Sheet: /power/
File: power.kicad_sch

Sheet: /opamp_amp/
File: opamp_amp.kicad_sch

Sheet: /clock/
File: clock.kicad_sch

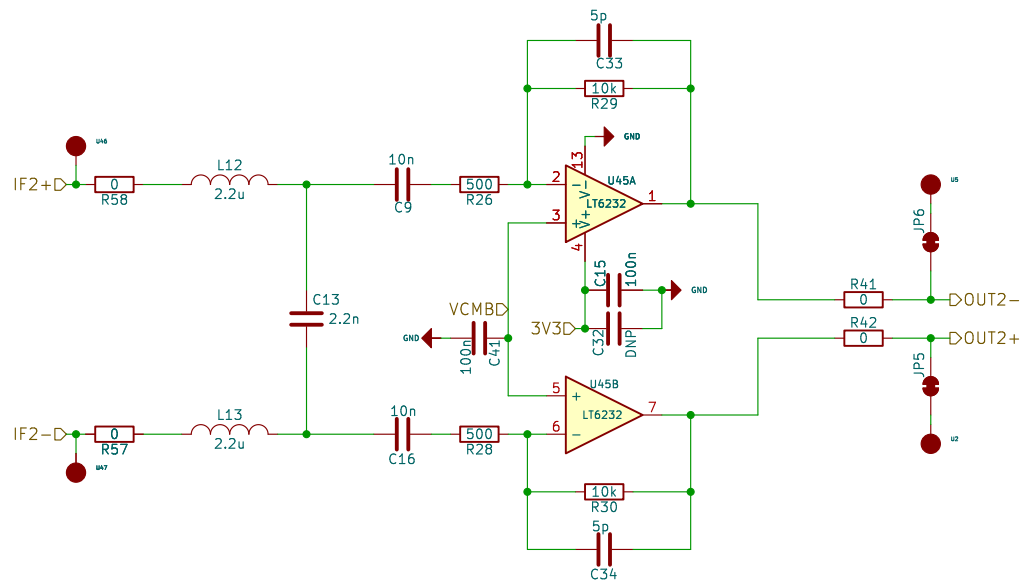
In the Artix-7 data sheet it states that the recommended power-on sequence is VCCINT, VCCBRAM, VCCAUX, and VCCO. 1v0 first 1v8 then 3v3 is the sequence so use power good

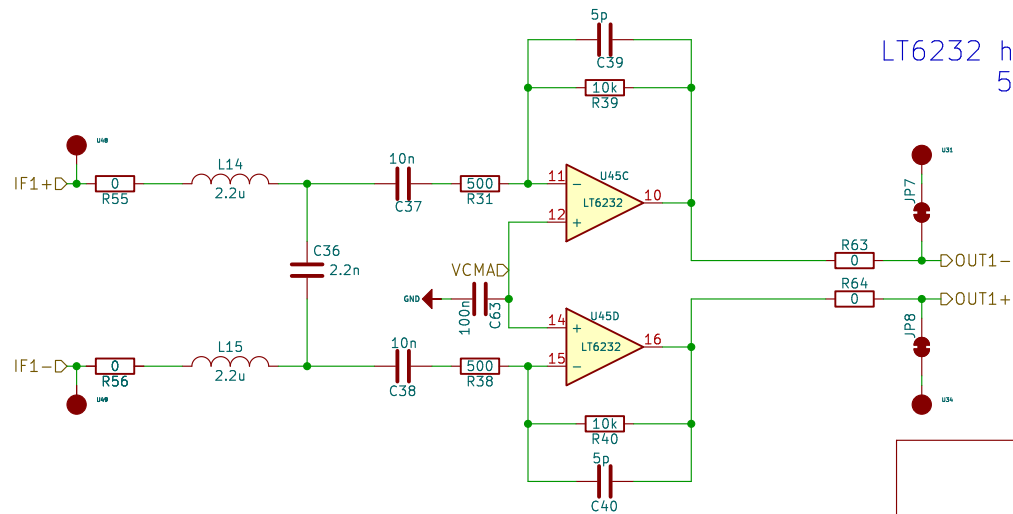
FPGA FIR Filter works perfectly.
Second stage for HPF
range compensation filter is removed

LT6232 has better noise performance as $1.1\text{nV}/\sqrt{\text{Hz}}$
500 10K has less noise contribution

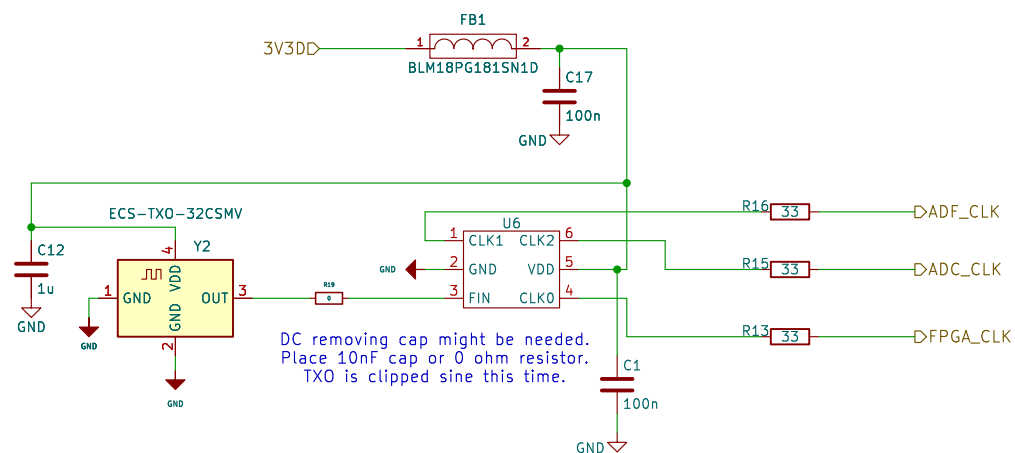
This is the prev design:
NB3N551 is obs.
Also this txo is generating pure sin.
ADC might need cmos like input not sin.
That could be the reason of duty stabilizer.
